- 5. Bonner Subdivision 2026 Replat (*Consent Agenda*)**
KPB File 2026-037
Seabright Survey & Design / Aurand, Jirsa
Location: Suchaview Road
Fritz Creek Area

**BONNER SUBDIVISION
2026 REPLAT**

**ITEM #5 - PRELIMINARY PLAT
BONNER SUBDIVISION 2026 REPLAT**

KPB File No.	2026-037
Plat Committee Meeting:	May 11, 226
Applicant / Owner:	Willia Jirsa & Julie Aurand / Homer, AK
Surveyor:	Katie Kirsis / Seabright Survey + Design
General Location:	East Skyline / Eagleaerie Ave, near Homer

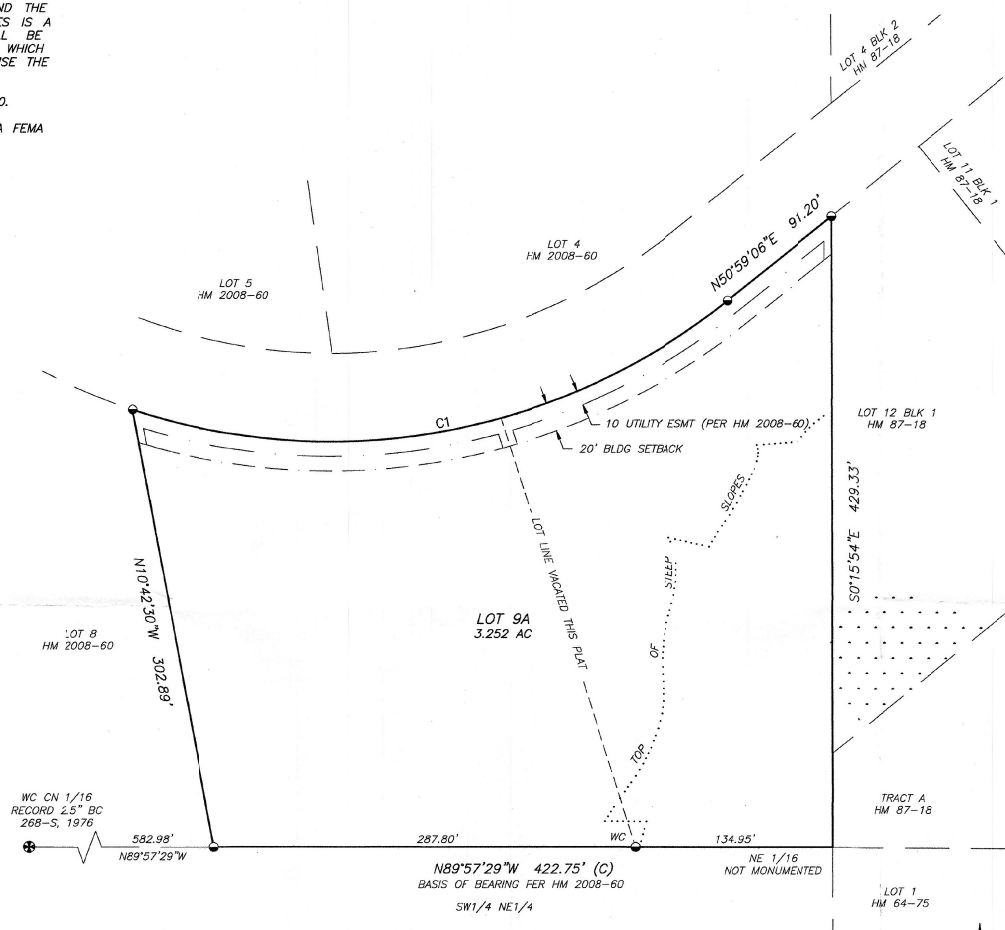
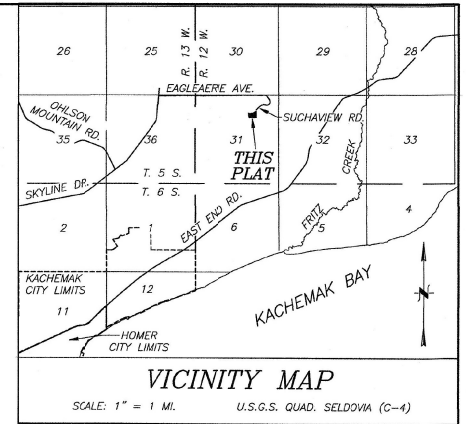
According to the parent plat there is a 4x4 Trail crossing this lot. **Staff recommends** the surveyor show this trail on the final drawing.

There is a steep area in the southeast corner of the plat occupying a large section of the corner. The top of the steep slope is identified on the plat. **Staff recommends** this line remain on the final plat and the surveyor add a line or arrow indicating the direction of drop of the slope. The slope is 100% meaning it is at a 45 degree angle in the southeast corner.

A soils report will not be required as the is combining two lots making fewer lots. Per KPB 20.40.020 wastewater system review will not be needed. The wastewater note in KPB 20.40.020.B.1 shall be shown on the drawing. **Staff recommends** the wastewater disposal note be review to match that as noted above.

In the Plat Approval change the date to May 11, 2026.

In the Certificate of Ownership, add to both lines name including middle initials.

Modify the KPB File No to 2026-037

The two lots are titled differently, one has the owners using the middle initials one within middle initials. Please add both names of both owners to the title block and the Certificate of Ownership as an AKA for one.

- C. The location, width, and name of existing or platted streets and public ways, railroad rights-of-way, and other important features such as section lines or political subdivisions or municipal corporation boundaries abutting the subdivision;
Staff recommendation:
Add name and ROW width to Suchaview Dr on the north.

- F. The location, width and name of existing and platted streets and public ways, railroad rights-of-way, easements, and travel ways existing and proposed, within the subdivision;
Staff recommendation:
Show 4x4 trail from parent plat

- H. Approximate locations of low wet areas, areas subject to inundation, areas subject to flooding or storm water overflow, and the line of ordinary high water. This information may be provided on an additional sheet if showing these areas causes the preliminary plat to appear cluttered and/or difficult to read;
Staff recommendation:
Show the area of Riverine continuing southeast to give idea of direction.

- M. Approximate locations of slopes over 20 percent in grade and if contours are shown, the areas of the contours that exceed 20 percent grade shall be clearly labeled as such;
Staff recommendation:
Show direction of the downslope from the top of the steep slopes
